REVISED RESPONSE TO REQUEST FOR ADDITIONAL INFORMATION

APR1400 Design Certification

Docket No. 52-046

RAI No.: 554-9146
SRP Section: 7.2 - Reactor Trip System
Application Section: 7.2
Date of RAI Issue: 09/18/2017

Table 2.5.1-5 (12 of 12)

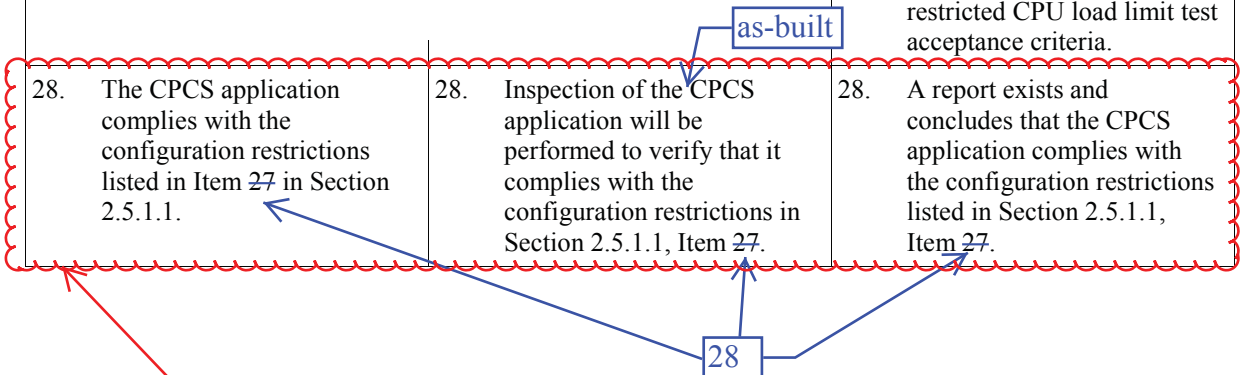
The staff finds that the additional sixteen configuration restrictions are safety significant in order to assure deterministic operations of the CPCS with the increased maximum load limit; therefore, the staff request the applicant to either:

- Include the sixteen configuration restrictions in Section 2.5.1, "Reactor Trip System and Engineered Safety Features Initiation," Tier 1, of the APR1400 DCD,
- or,
- Incorporate by reference, the proprietary technical report APR1400-A-J-NR-14004, and identify it as a "Tier 1" document.

In addition, Tier 1 Table 2.5.1-5 is modified as indicated in the attachment, so that additional fifteen restrictions are provided clearly.

27. The CPCS configuration restrictions and tests for the CPU load have been implemented.	27.a Inspection and analysis will be performed of the as-built CPCS equipment to verify that the CPCS configuration restrictions for the CPU load are designed into the final CPCS design.	27.a A report exists and concludes that the CPCS configuration restrictions for the CPU load are designed into the final CPCS design.

27.b CPU load test of the as-built CPCS will be performed.	27.b The as-built CPCS equipment meets the restricted CPU load limit test acceptance criteria.

28. The CPCS application complies with the configuration restrictions listed in Item 27 in Section 2.5.1.1.	28. Inspection of the as-built CPCS application will be performed to verify that it complies with the configuration restrictions in Section 2.5.1.1, Item 27.	28. A report exists and concludes that the CPCS application complies with the configuration restrictions listed in Section 2.5.1.1, Item 27.
